# SAS-2 10-Meter Cable Specification Issues (06-499r0)

Barry Olawsky  
Hewlett Packard  
(SAS FTF - 11/7/2006)

# Issues for Discussion

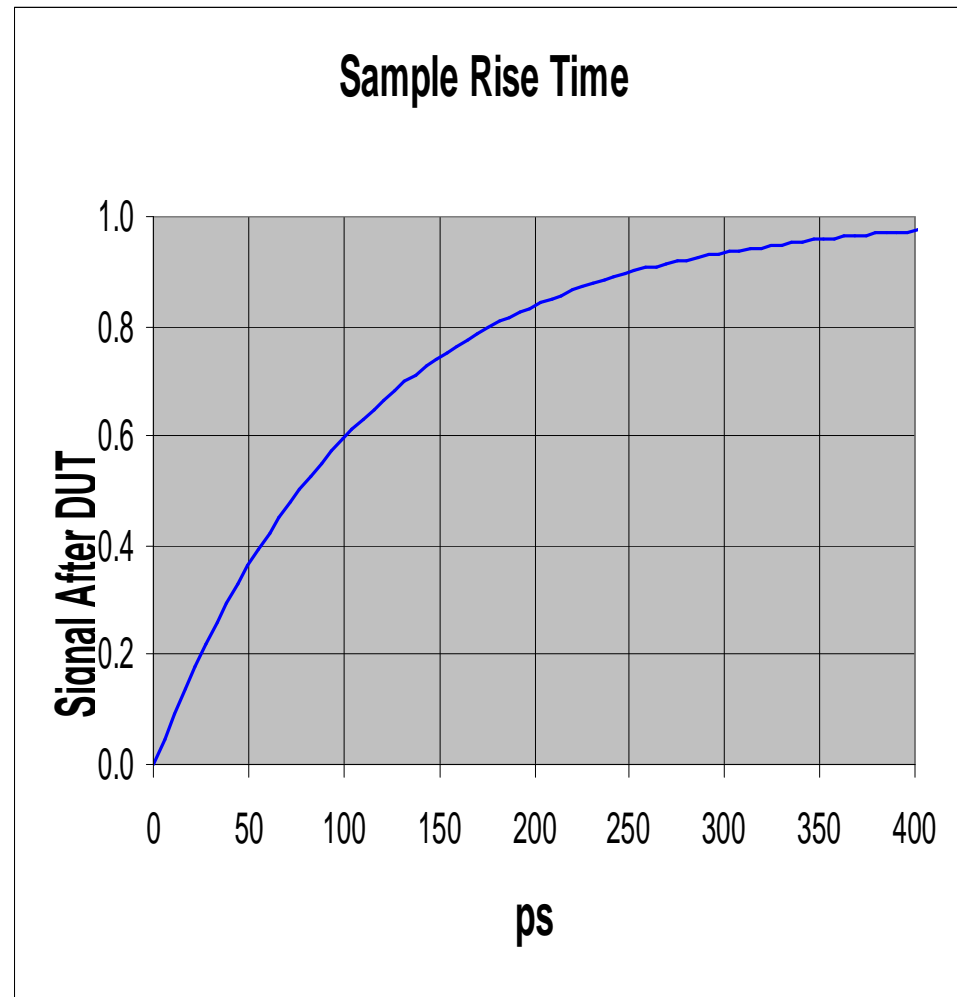
- The original intent of TCTF was a test load definition and not an insertion loss mask. Insertion loss mask specifications are problematic because they either disqualify designs with adequate margin or if specified too leniently, pass designs which are prone to interoperability issues due to insufficient margin.
- Intra-skew spec is difficult to meet on longer cables. The significance of intra-pair skew needs to be proven. Don't expect a common mode conversion specification to be any easier to meet.
